From: [Sean Noonan](#)
To: [Edgar Gonzalez](#)
Subject: Comment on IS/MND for Tentative Tract Map 20637 (TT23-00004)
Date: Wednesday, February 18, 2026 4:03:47 PM

Tentative Tract Map 20637 (PROJECT)
 MITIGATED NEGATIVE DECLARATION (MND)
 SCH# 2026020360

Subject: The draft Initial Study and Proposed Mitigated Negative Declaration for Tentative Tract Map 20637 (TT23-00004) SCH# 2026020360

SUBMITTED:	APPROVED:	DATE:
[Signature]	[Signature]	
APPROVAL RECOMMENDED:	CHIEF DESIGN BRANCH, D.B.C. RES. C.E. NO. 7287	
[Signature]	DRAWING NO.	SHEET NO.
	N-29FI-17	26

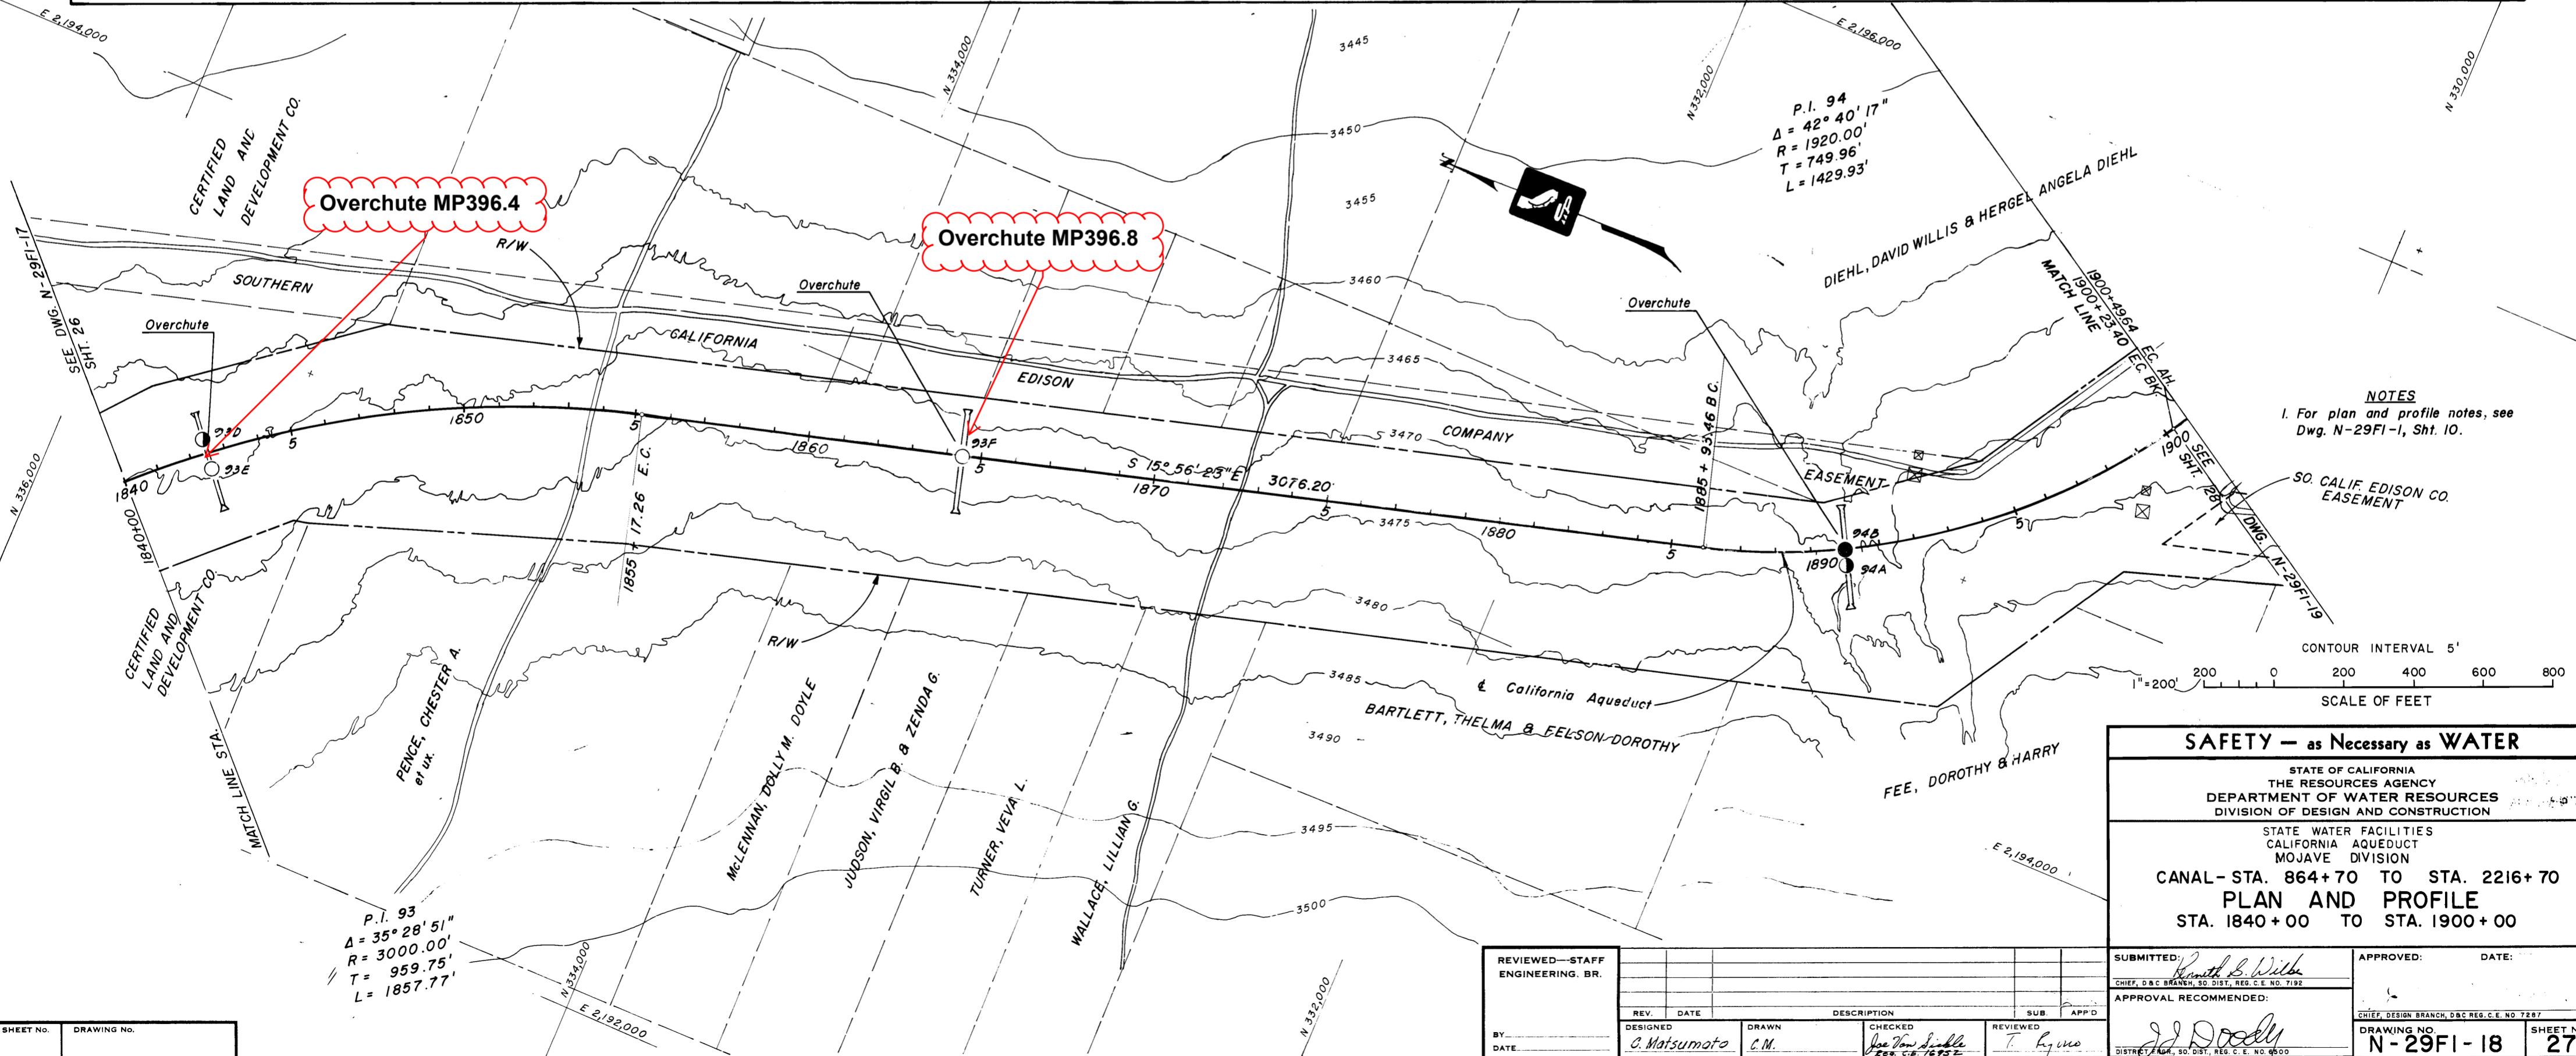
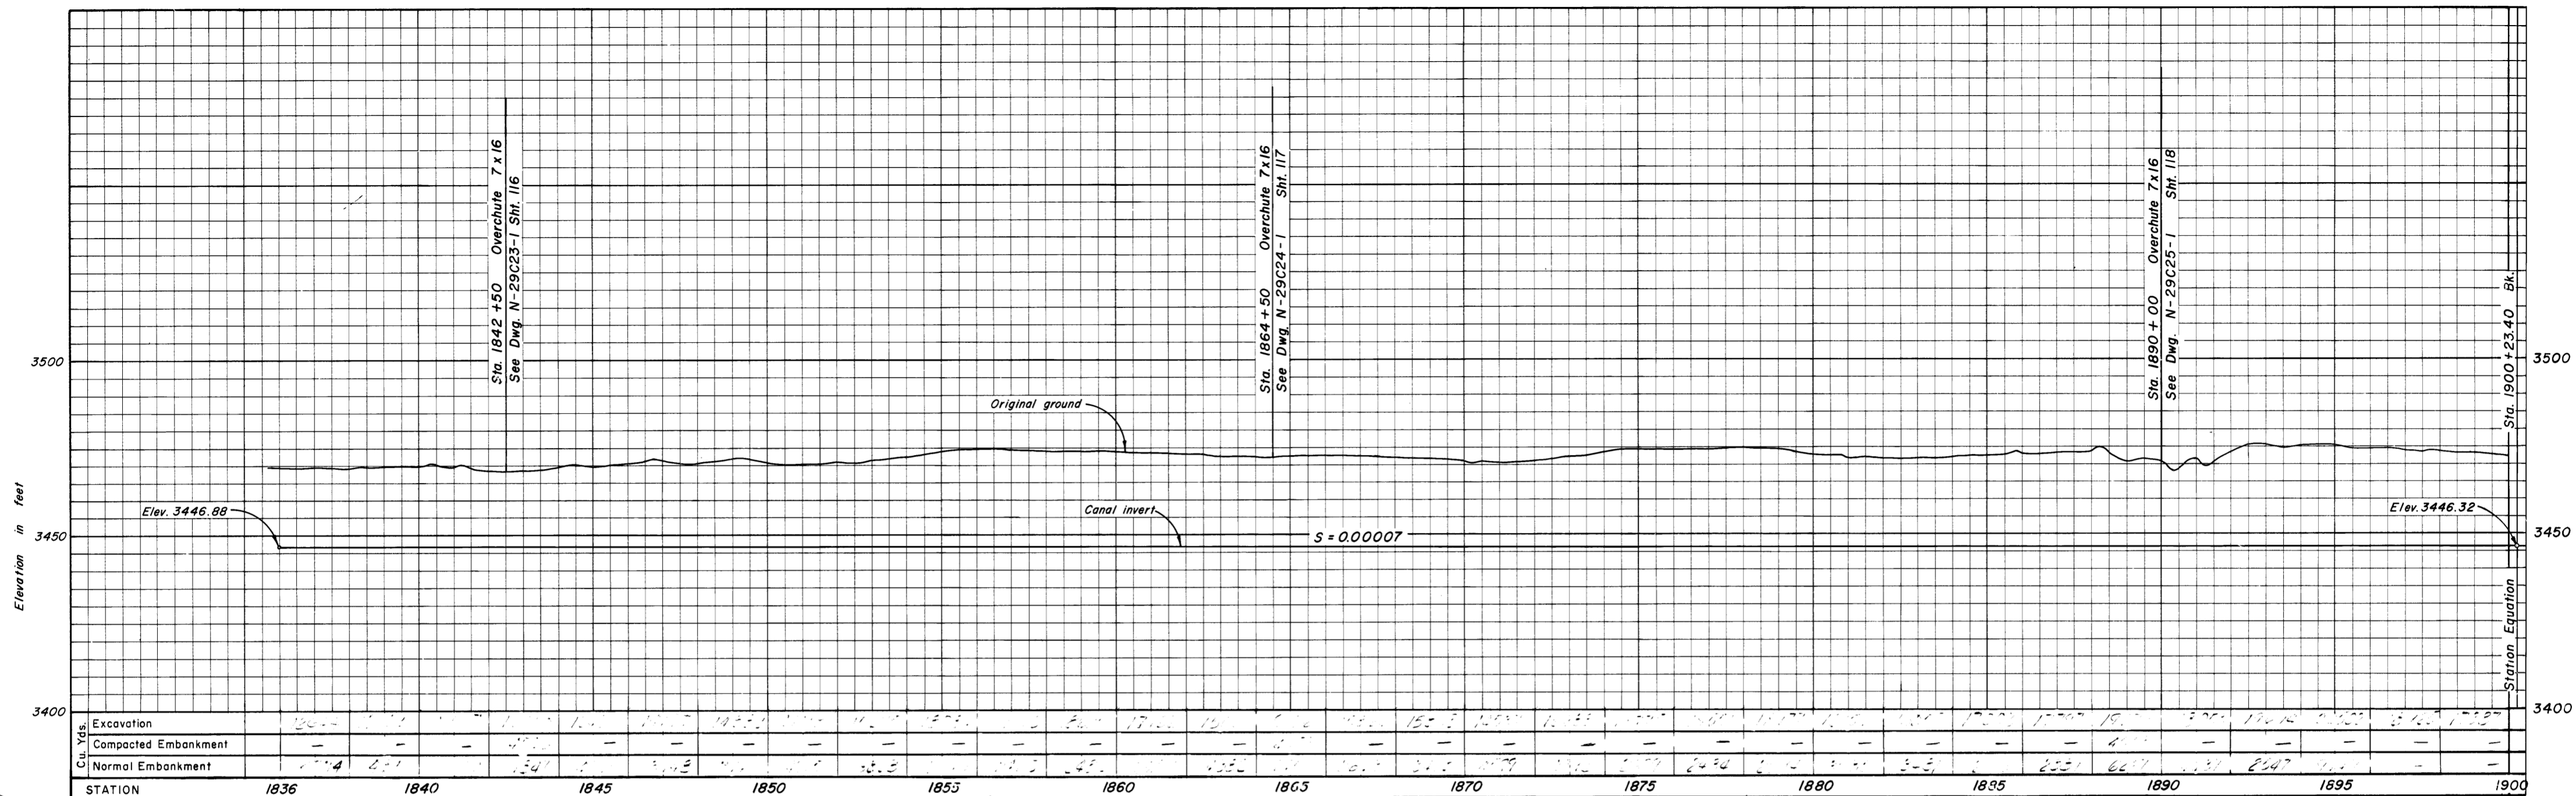
1. MP396.1 Overchute crossing over the Aqueduct located at the north end of Fuente Ave. See attached DWR As-built Drawing No. N-29F1-17, N-29C22-1, N-29C91-30.
2. MP396.4 Overchute crossing over the Aqueduct located at east end of Sultana St and DWR right of way west boundary. See attached DWR As-built Drawing No. N-29F1-18, N-29C24-1, N-29C91-31.
3. MP396.8 Overchute crossing over the Aqueduct located at east end of Pinellia St and DWR right of way west boundary. See attached DWR As-built Drawing No. N-29F1-18, N-29C23-1, N-29C91-31.

flows to this concrete lined ditch or the DWR Overchutes located at Mille Post 396.1, 396.4 or 396.8. All the Overchutes located along Aqueduct convey drainage flows from west to east side of the Aqueduct. Currently there is erosion on the outlet side of these Overchutes from the concentrated drainage flows from existing drainage basins listed above. This is mainly due to absence of concrete lined channel at the Outlet Side because concrete lined channels were only constructed up to the inlet structure as part of the adjacent development projects. The impact analysis for off-site erosion and siltation impacts needs to explain whether any potential overflow from proposed retention basin located at Lot A may flow to any of the drainage basins or DWR Overchutes listed above.

If the proposed development will divert drainage flows towards a nearby DWR Overchutes which currently receive concentrated flows from a development adjacent to the Proposed Project, additional Proposed Project flows are likely to increase the existing erosion within DWR right of way on the outlet side. Concrete lined channels on the downstream end may be needed to mitigate the Proposed Project erosion impacts. See attachment for DWR Hydrologic & Hydraulic Data which shows the structural capacities (cfs) of all the DWR Overchutes listed above. Hydrology and Drainage Analysis for proposed development is also needed to assess the flows (cfs) and flow velocities through DWR Overchutes to determine if energy dissipation structures or any improvements are needed on the inlet side within DWR right of way to prevent erosion, scour or damage to DWR Overchute Structures.

3. The County/Project Applicant shall ensure that no runoff from the proposed development enters DWR Right of Way and that any modifications to the natural discharge flows through DWR Overchutes do not result in backing-up of stormwater flows onto the DWR right of way.
